10/809,995

Mi-Sook Nam

Office Action Summary

Claims 18-26, 28-30, 36 and 38 are rejected under 35 U.S.C. 103(a) as being unpatentable over US 6809785 B2 (785) in view of US 6885418 B2 (418).

FIG.2B

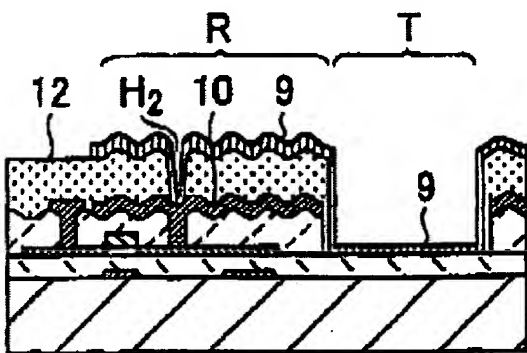
Per claim 18, 785 teaches a fabricating method of an array substrate for a transfective liquid crystal display device, comprising: forming a gate line [see G] and a data line on a substrate [D], the gate line and the data line crossing each other to define a pixel region having

reflective and transmissive portions; forming a thin film transistor connected to the gate line and the data line; forming a first passivation layer on the thin film transistor [5], the first passivation layer having a plurality of protrusions in the reflective portion [see figure above], wherein the plurality of protrusions are formed by patterning the first passivation layer [see column 3, process step D], and wherein a top surface of the first passivation layer between the plurality of protrusions is substantially even [see photomask shown in figure 8]; forming an uneven reflective layer on the first passivation layer in the reflective portion that has unevenness at least in part due to the plurality of protrusions [10]; and forming a pixel electrode on the first passivation layer [9]; providing a second substrate having a color filter layer [see column 3, 3rd full paragraph]; and common electrode on the surface of the overcoat layer [see column 3, 3rd full paragraph]; and disposing the first substrate such that reflective and transmissive portions of the first substrate oppose the corresponding regions of the second substrate [inherent].

Per claims 19 and 24, 785 teaches the method according to claim 18, further comprising forming a second passivation layer on the reflective layer and the pixel electrode on the second passivation layer [see silicon oxide layer 12 above].

Per claim 26, 785 teaches the method according to claim 19, further comprising forming a contact hole through the first and second passivation layers and connecting the pixel electrode to the thin film transistor through the contact hole [see contact holes in the above figure].

Per claim 28, 785 teaches the method according to claim 18, further comprising substantially maintaining a thickness of the first passivation layer between the transmissive portion and a section of the reflective portion in which the transistor is absent [see figure above].
